Elevation QC Report

Project: OR_CVO-Newberry-Del2_2010

Contractor: Watershed Sciences

Date Data Reviewed: 08/16/2011

OR CVO-Newberry-Del2 2010: Example of Classified LAS “grounds” Within Boundary of Waterbody

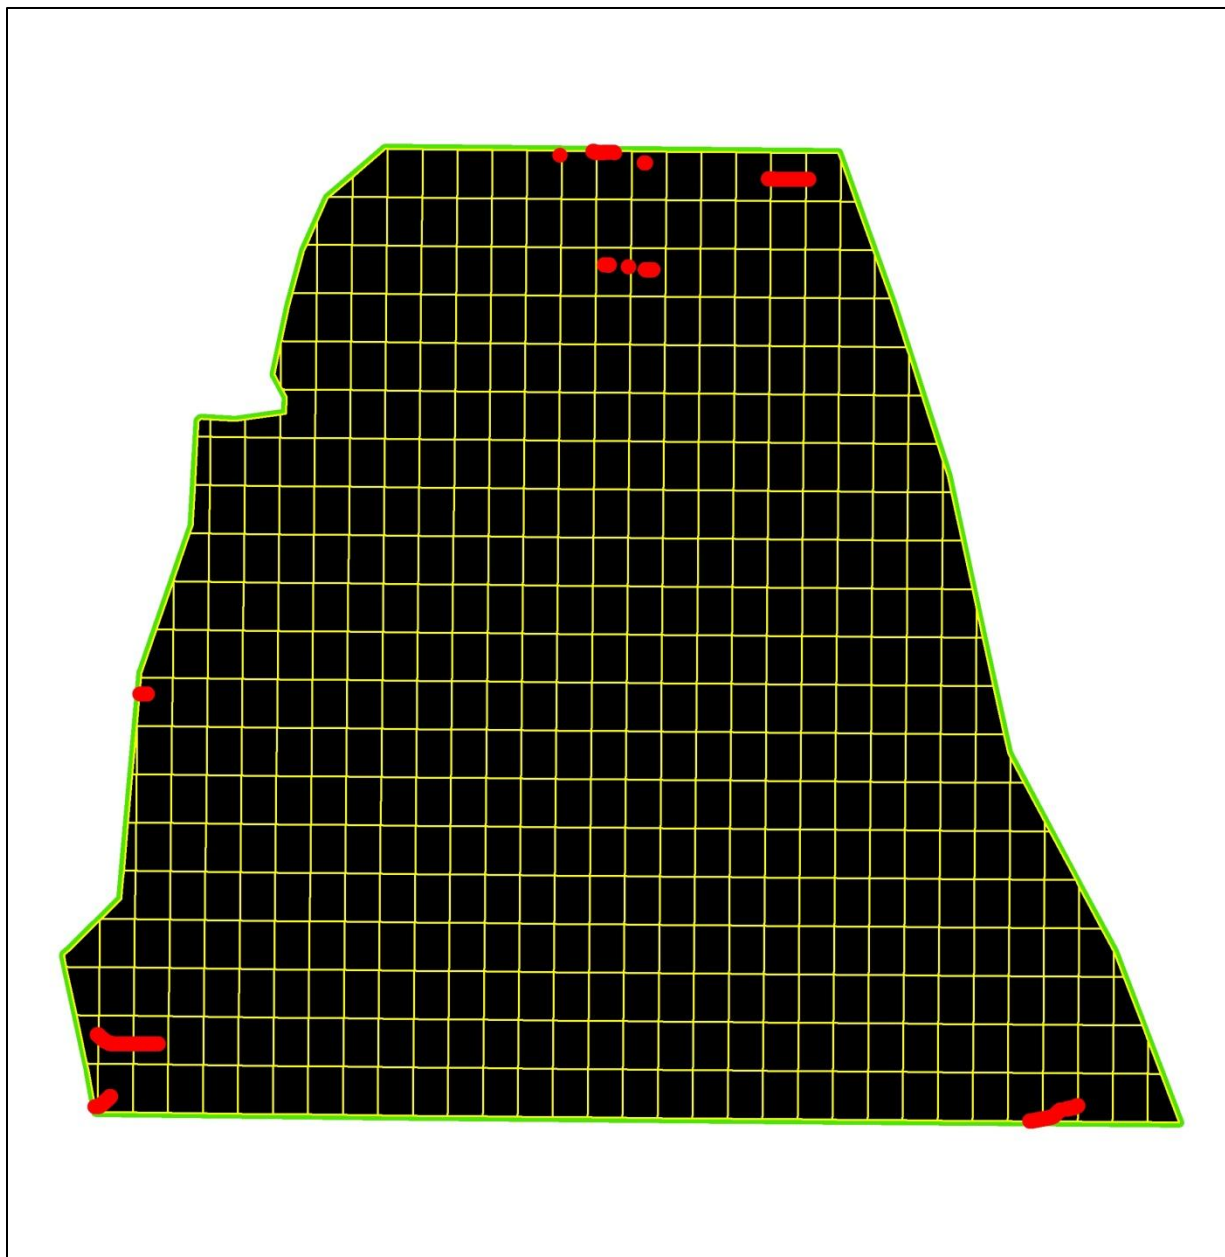
Reviewer loaded the LAS "grounds" into Global Mapper. LAS conformed to the 100th quad tiling scheme. Global Mapper filter showed only "ground" classification for these points. One issue the reviewer found with the LAS "ground" classified points was that most waterbodies contained points classified as "ground". An example is provided below.

OR CVO-Newberry-Del2 2010: Example of Building (1) Not Removed

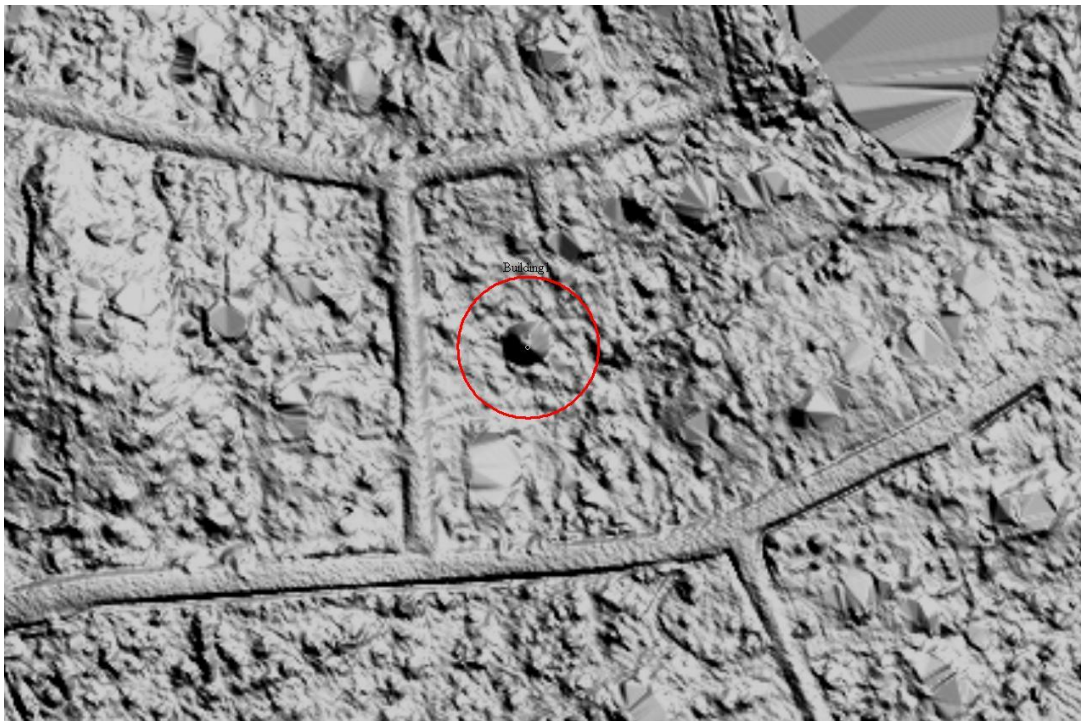
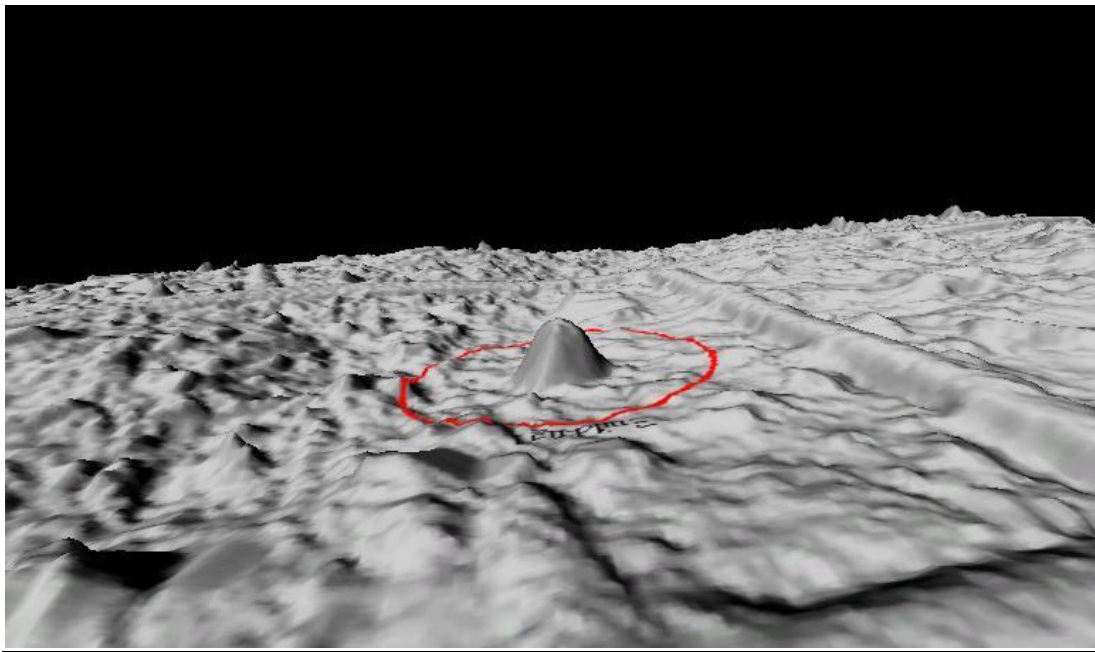
Bare earth surface is good. Through the majority of the project, there is not excessive "over-editing" of the bare earth points. Most vegetation, bridges, and buildings appear to be removed properly. Reviewer created an errors shapefile showing buildings that were not completely removed. Examples are provided below. Reviewer found artifacts along the edges of tiles. Such artifacts are included in the errors shapefile. Examples are provided below. The surface is free from very high points that are most likely noise, and quilting.

OR CVO-Newberry-Del2 2010: Example of Waterbodies Not Flattened

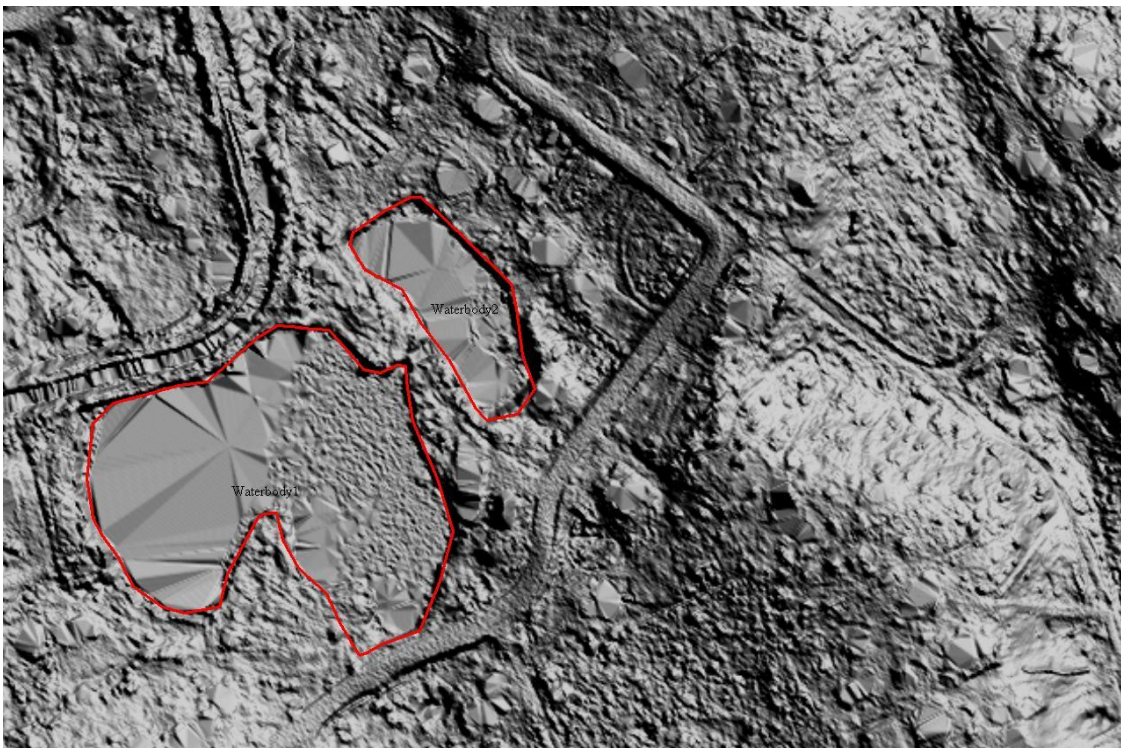
There was no requirement for treatment of waterbodies or double line streams, therefore waterbodies are not flattened and double line streams have not been forced to drain downhill. Reviewer created an errors shapefile showing waterbodies that have not been flattened for reference purposes. Examples are provided below.
